1992 Corvette ZR-1: Service Bulletin: Lack of Wide Open Throttle Engine Underpower

Subject: LACK OF WOT-LOW ENGINE POWER REVISED CABLE ADJUSTMENT PROC.

Bulletin Number: 92-214A-7B - (07/01/1992)

THIS BULLETIN CANCELS AND SUPERSEDES DEALER SERVICE BULLETIN NO. 92-214-7B, DATED JUNE 1992. THE THROTTLE OPENING NOTATION UNDER "CORRECTION" HAS BEEN CORRECTED. ALL COPIES OF 92-214-7B SHOULD BE DISCARDED.

THROTTLE BODY AND ACCELERATOR PEDAL CABLE ADJUSTER

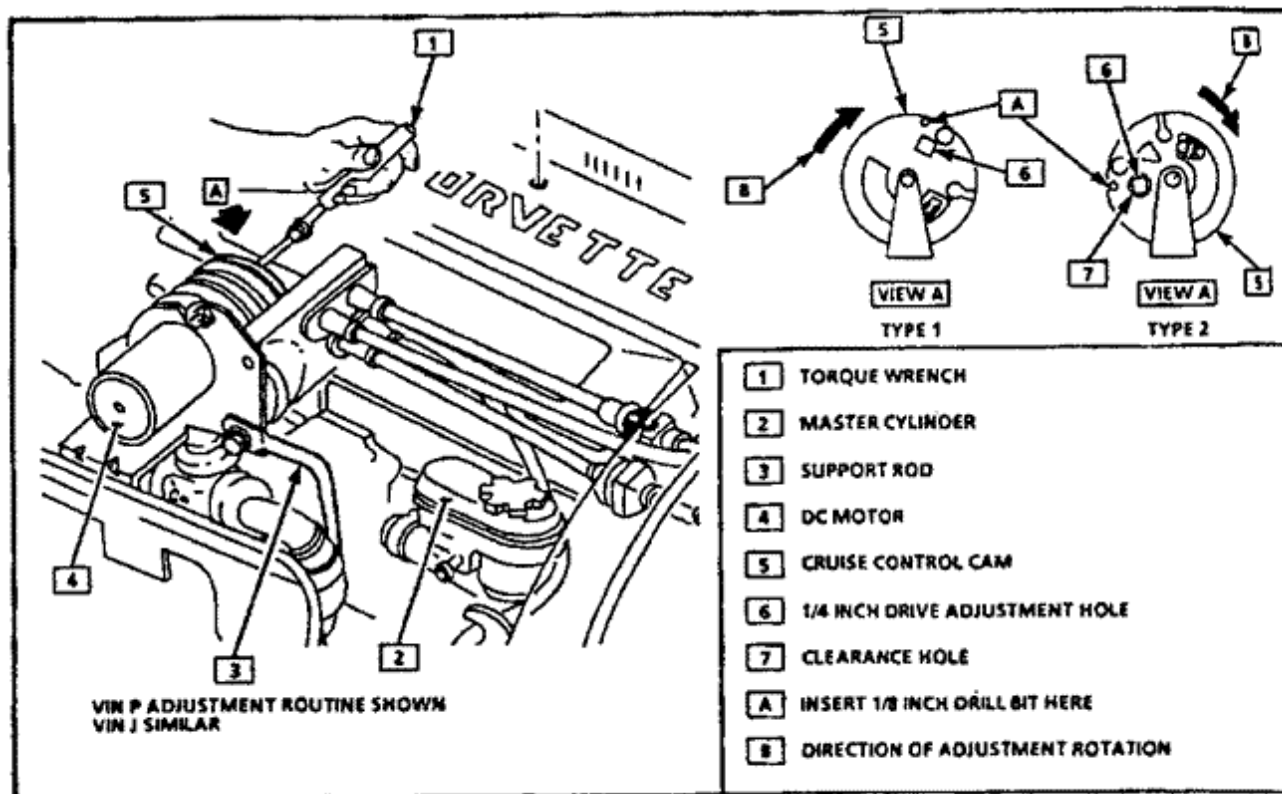
BEFORE MAKING ANY ADJUSTMENT, use a Tech 1 with an 88-92 Brake System Cartridge, check throttle angle percentage by depressing the accelerator pedal. When the pedal is fully depressed, throttle opening should be 100 percent. When the accelerator pedal is released, throttle opening should return to 0 percent. If proper results are not obtained, follow the revised ABS/ASR system adjustment procedures below to improve the above

1. Remove adjuster cam assembly splash cover, foam shield, and cable cam cover.
2. Disconnect cruise control cable from the cruise control servo.
3. Depress reset button on the throttle control cable and fully extend cable sheaths (see figure).
4. Insert a 1/8 inch drill bit into adjuster assembly alignment hole (see figure, item A).

5. Insert a torque wrench with a 1/4 inch drive extension into square hole on the cruise control cam (type 1) or through the cruise control cam into the accelerator cam (type 2) (see figure, item 6).
6. Turn the torque wrench clockwise until obtaining a torque of 4 N.m (35 lbs. in.). During adjustment, several clicks of the adjuster should be heard. If not, repeat step 3.
7. Remove the torque wrench AND drill bit.

10. Using a Tech 1 with an 88-92 Brake System Cartridge, check throttle angle percentage by depressing the accelerator pedal. When the pedal is fully depressed, throttle opening should be 100 percent. When the accelerator pedal is released, throttle opening should return to 0 percent. If proper results are not obtained, check cables for kinks or damage, and repeat adjustment procedures.
